July 16, 2024

SCH #: 2024060688  
GTS #: 04-SCL-2017-01295  
GTS ID: 7642  
Co/Rt/Pm: SCL/152/R30.43

### **Re: Design Level Geotechnical Investigations for the Pacheco Reservoir Expansion Project – Mitigated Negative Declaration (MND)**

### Small Culverts (APR)

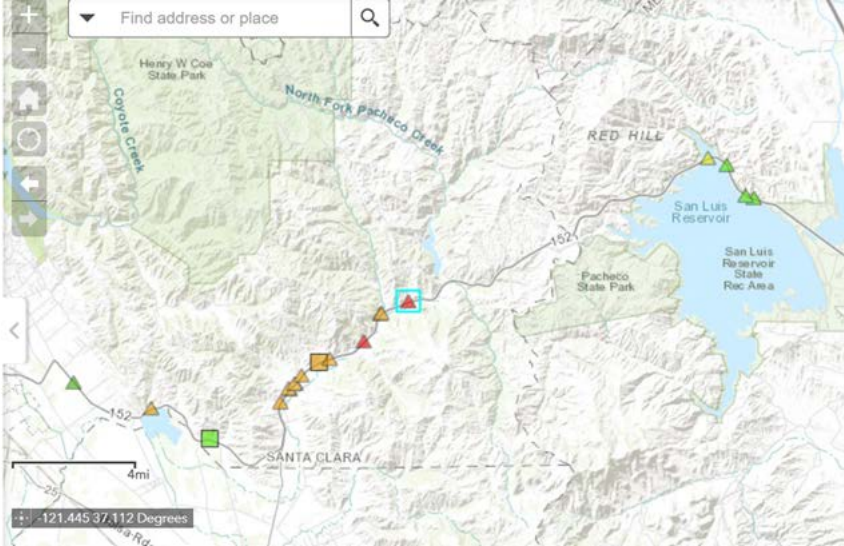
Please keep Caltrans informed about developments and implementations of various climate stressors, as well as ongoing adaptation and resilience initiatives at this project location near SR 152. A particular area of concern is the vulnerability to wildfires at this project location. Wildfires poses a significant risk along Caltrans' ROW, particularly affecting critical infrastructure such as culverts. Please see attached image of culverts around the project area.

The choice of culvert material determines susceptibility to direct wildfire damage. Culverts made from High-density polyethylene (HDPE), Polyvinyl Chloride (PVC), corrugated steel pipe, composite materials, and wood are more susceptible to wildfire damage. As a result, small culverts constructed from these materials, exposed to elevated wildfire risk, have been prioritized for adaptation measures.
